# Historic Preservation Design Review

February 25, 2010

HP-10-04, 237 Church St. (City)

**Request:** Design Review for addition of porte cochere, proposed parking lot and landscaping changes at Sumter Pediatrics

*Left: Existing Sumter Pediatrics facility with covered entrance. The proposed porte cochere will match the existing building colors and materials.*

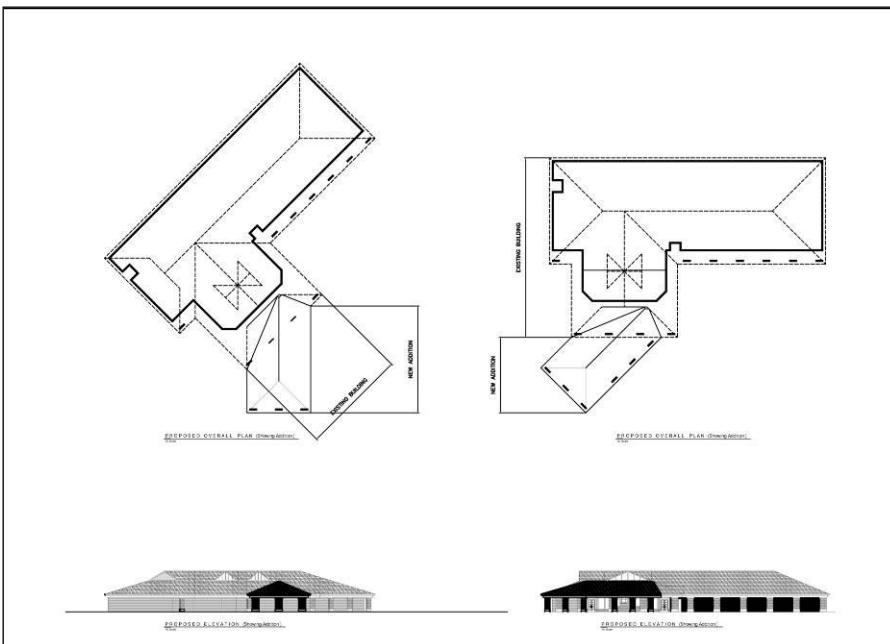
Due to the age and nature of this structure, no specific design review guidelines address this type of proposal. In general new construction within the historic district should adhere to traditional building materials such as masonry with wood or stone. When the building was originally constructed wood and brick were the chosen materials.

*Left: Plans and elevations of the proposed porte cochere.*

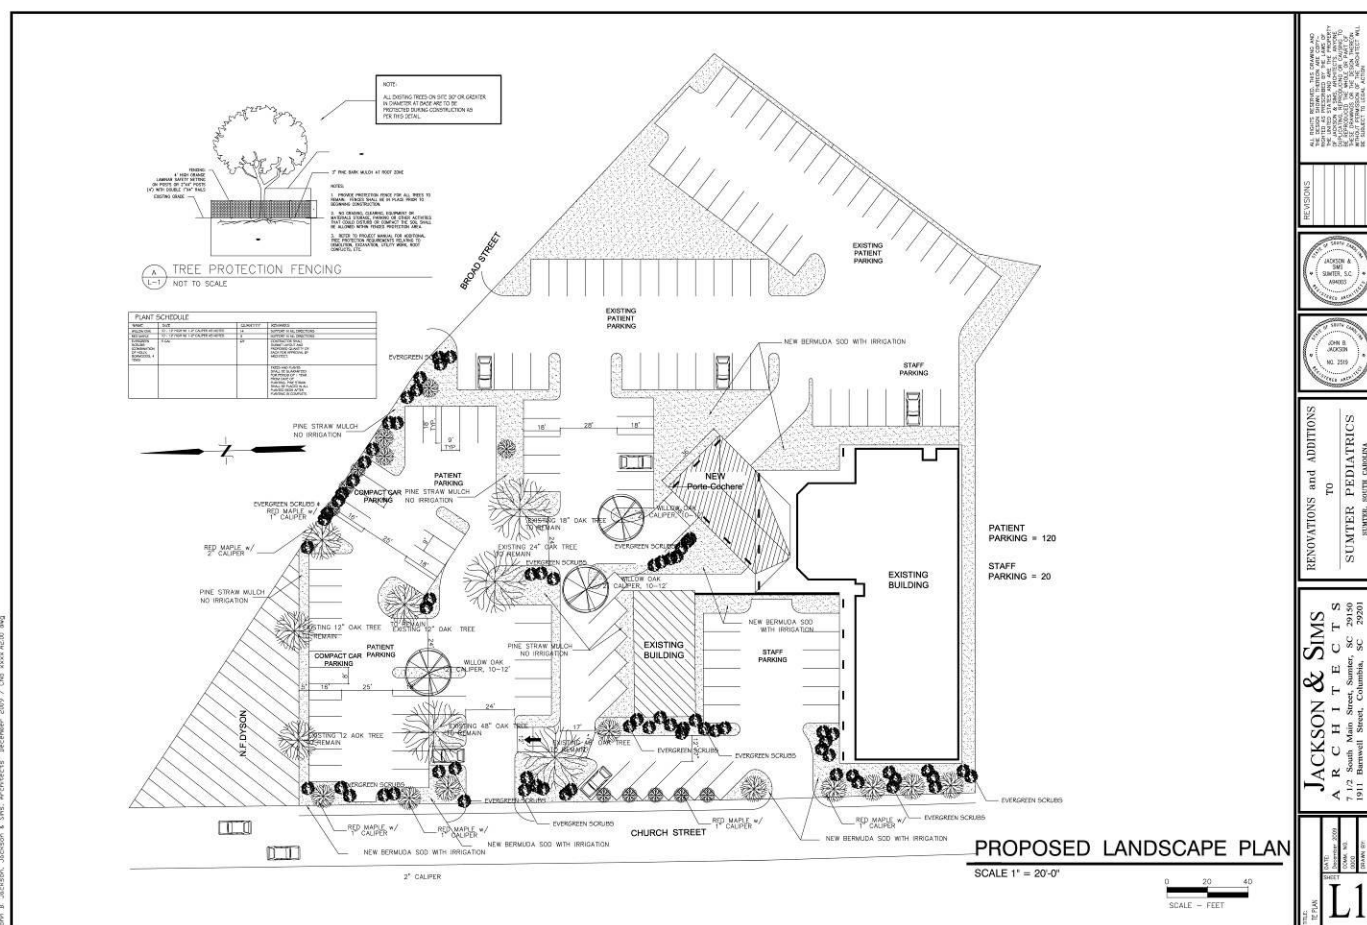
While there are no specific design criteria that address the changes to this project, materials and design should be reviewed in the context of the historic district in terms of building materials and colors. A landscape design has been submitted which shows several issues that are to be addressed as variance requests with the Board of Zoning Appeals. There are also several historic and significant trees on site that the owner intends to preserve during construction. A historic tree is any tree greater than 30" dbh (diameter at breast height), and significant trees are greater than 10" dbh (except for live oaks, which are considered significant at 8" dbh).

Staff recommends approval of this request provided that the applicant preserves the existing historic and significant trees on the site.
